My name is **Dr Bridget Sutton**. I have a PhD in Chemistry and a Post-Graduate Certificate in Education from Darwin College, University of Cambridge.

** Invite Inspectors to see for themselves, around 9 a.m., how the C2C busway would cut across a mishmash of existing busy pedestrian & cycle routes.*

Figure 1 Created by overlaying Works plan sheet 15 & 16. Intersection with cycle paths circled red.

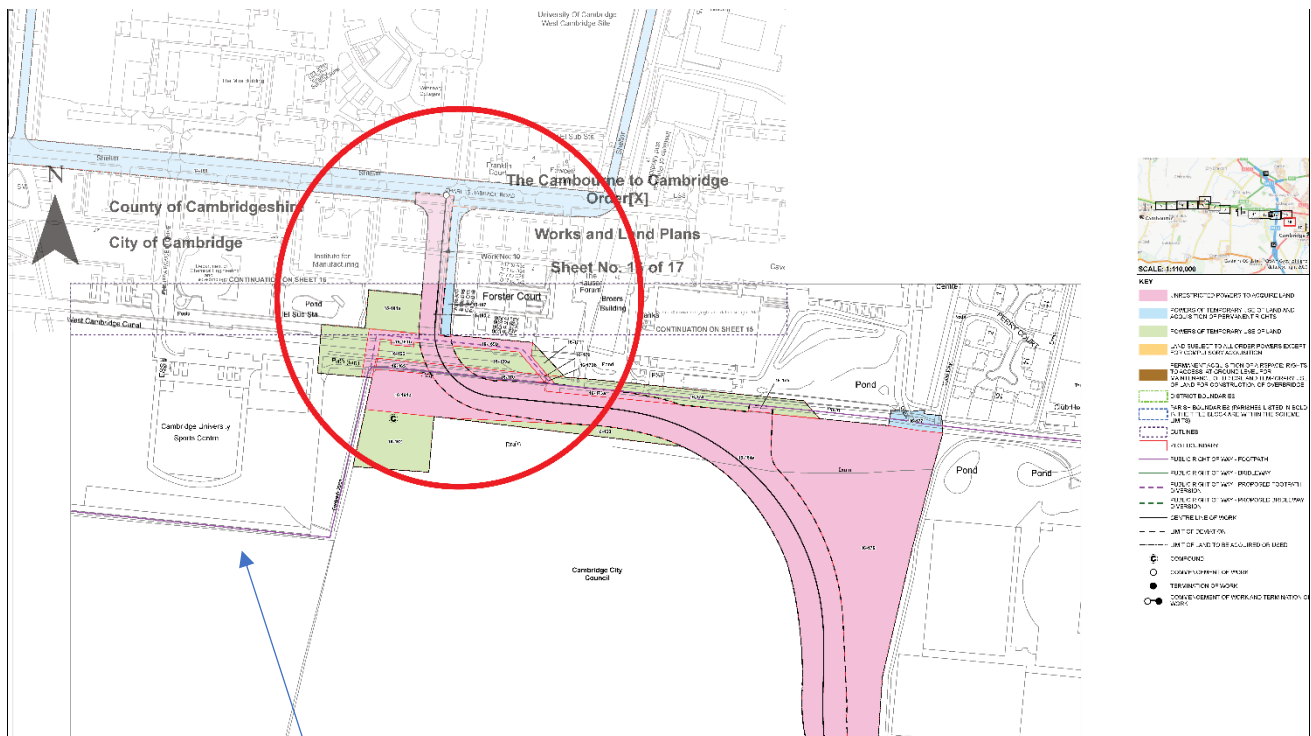
My cycle route is usually along the **Coton Footpath**, part of what is now the proposed **Comberton Greenway** — a route that already enables safe, low-carbon travel between the villages and the city — and one that, under these plans, would be crossed every few minutes by buses near the **Cambridge University Sports Centre**¹.

Note Footpath 39/31 is Public Bridleway-Harcamlow Way/WimpoleWay
